# Plan Commission

### Agenda

| Monday, January 23, 2017 | 7:00 PM | De Pere City Hall Council Chambers |

**SUBJECT:** Recommendation regarding a Revised Site Plan request at 1212 N. Enterprise Drive in De Pere for a warehouse addition and parking lot expansion (Parcels ED-2070 and ED-2069). Applicant: Mach IV Engineering & Surveying LLC

SHEET:  
C5.1

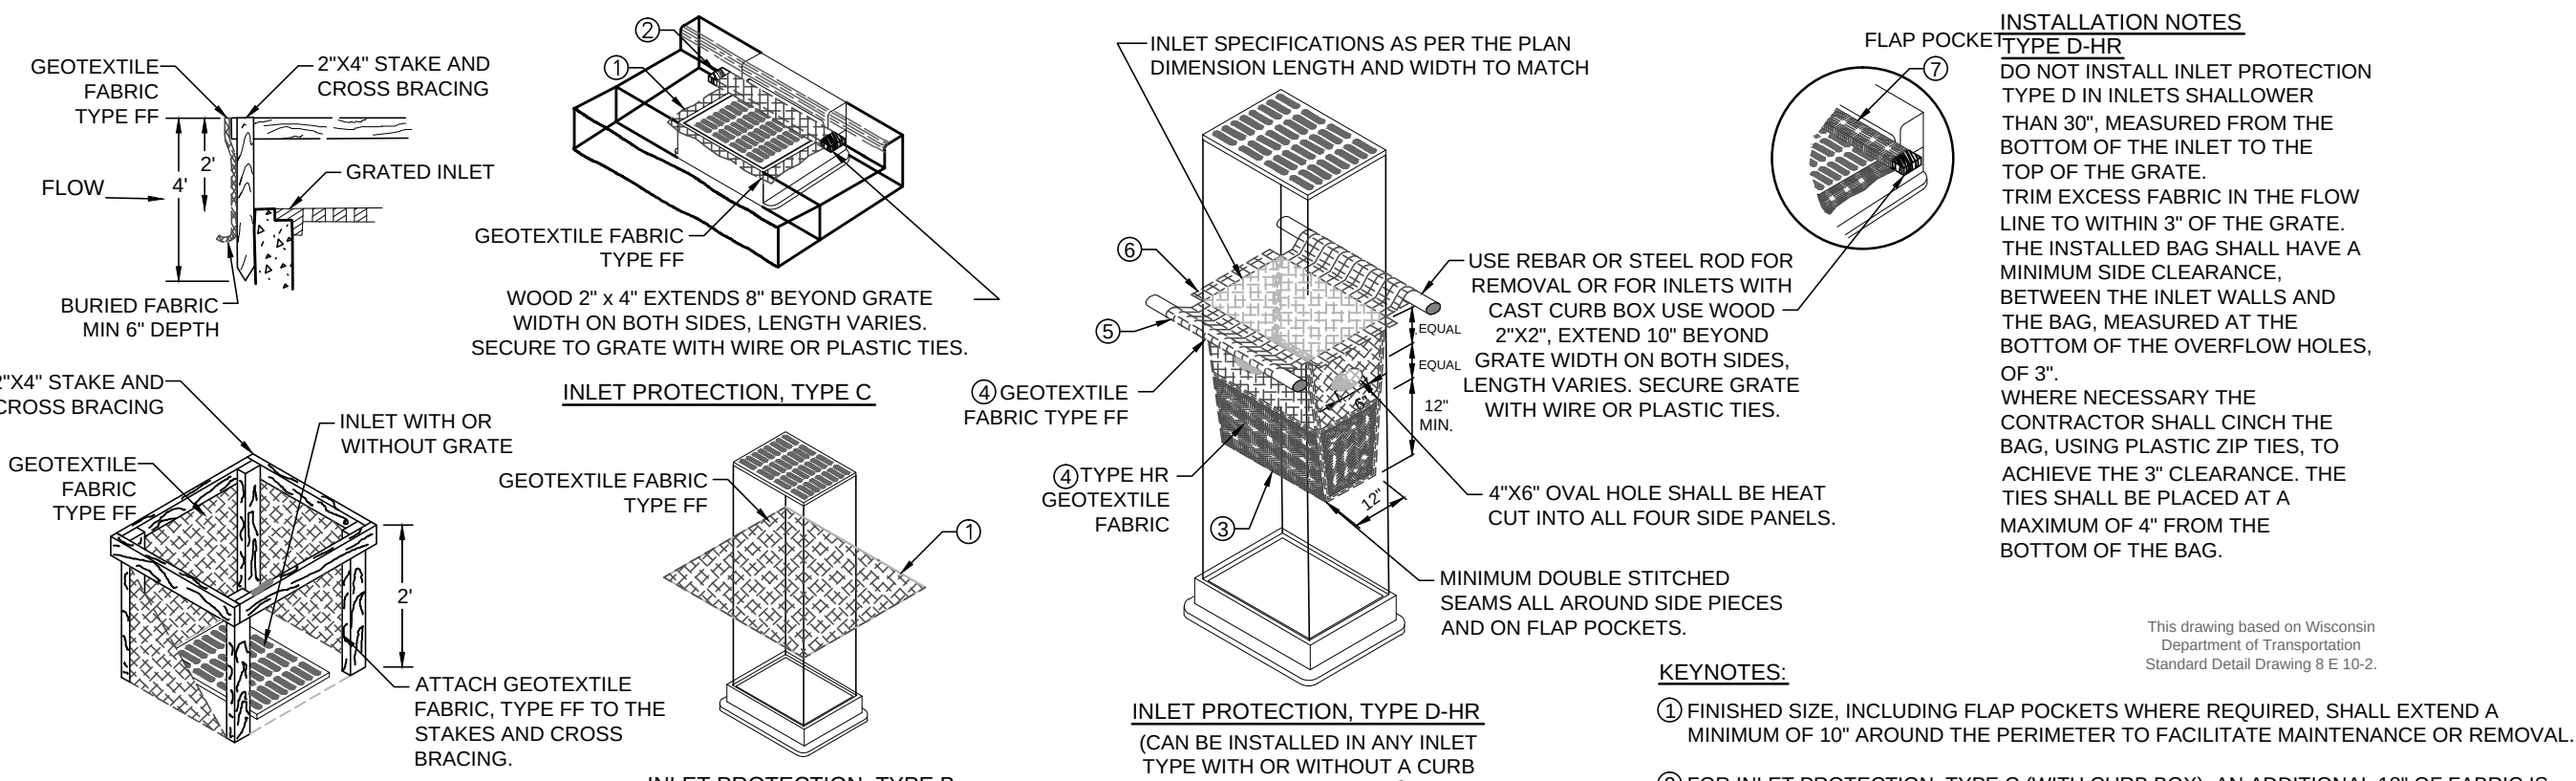
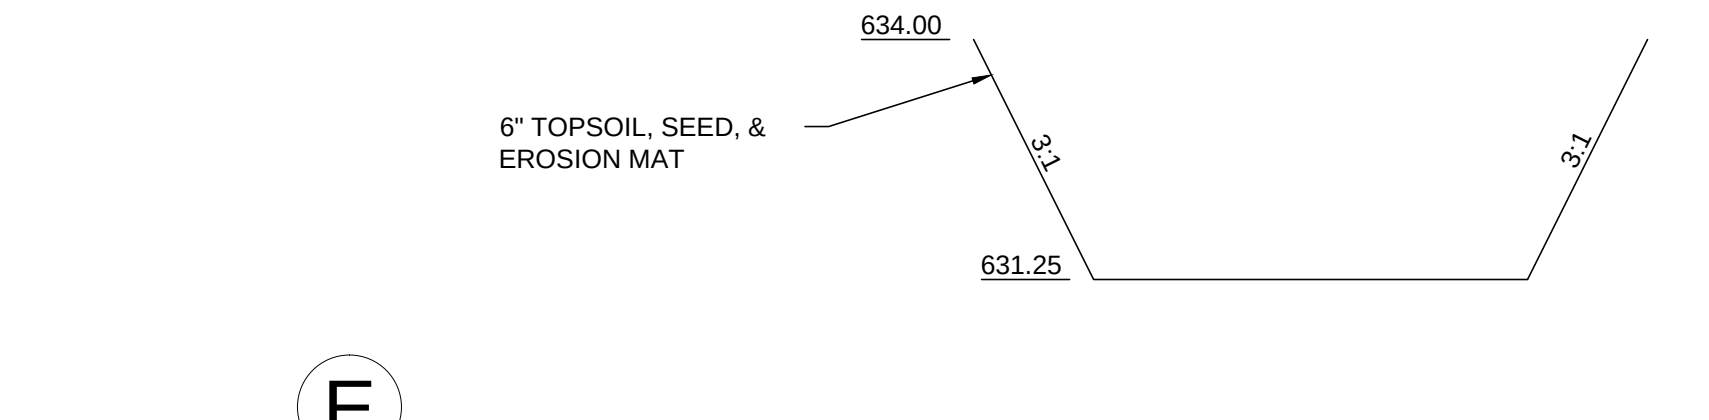
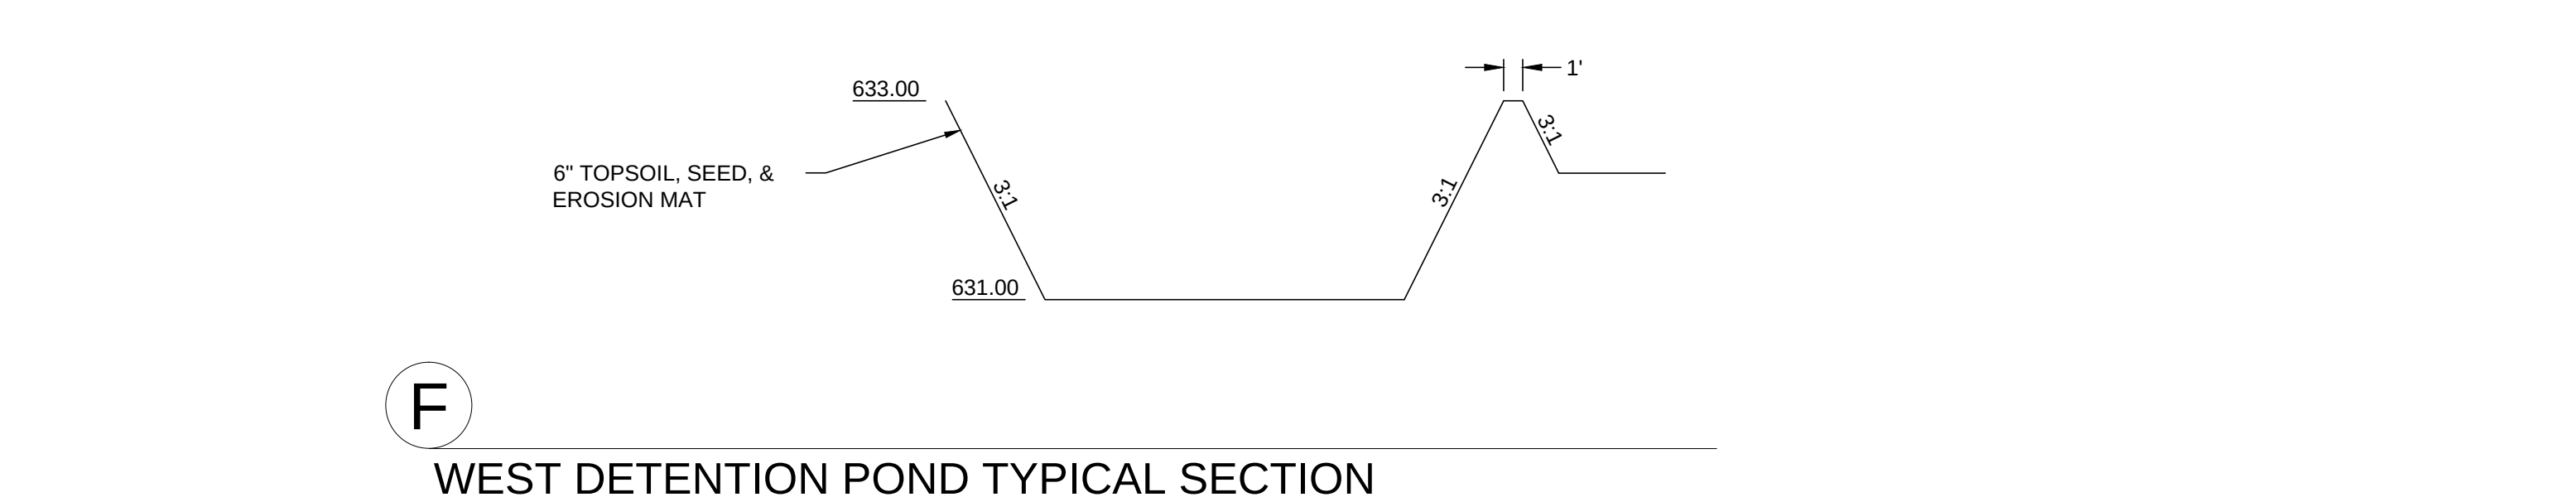
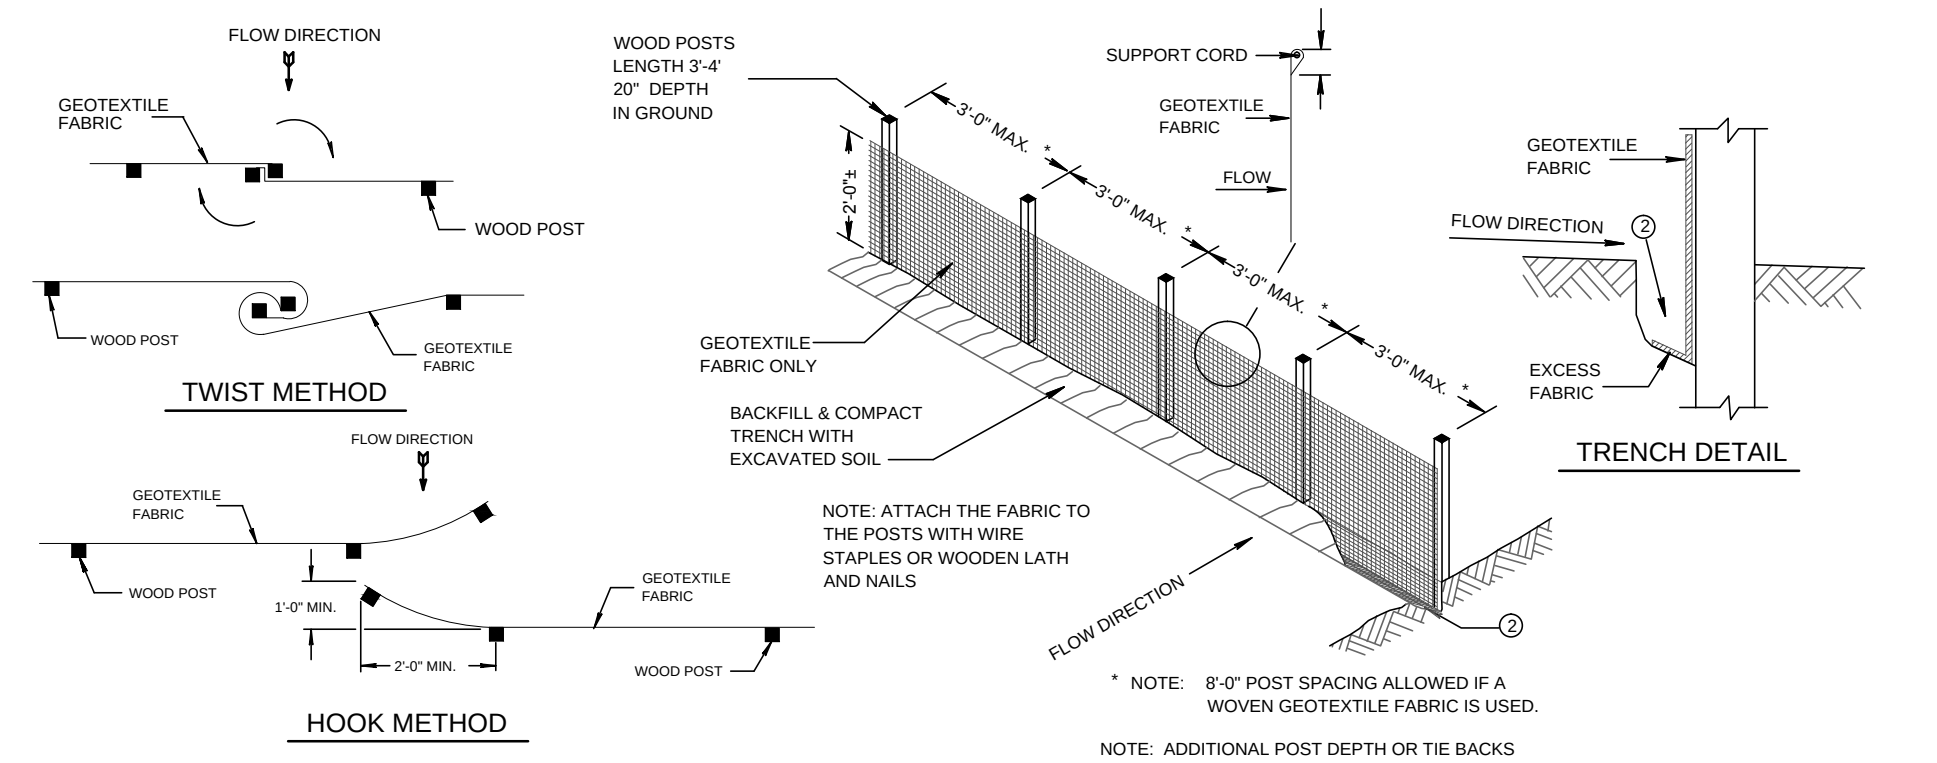
13. Update the pond typical sections on the Erosion Control Plan sheet C5.1 (slopes). Updated.
14. Show the site address on the cover page. It is only found on sheet C2.0 Updated.
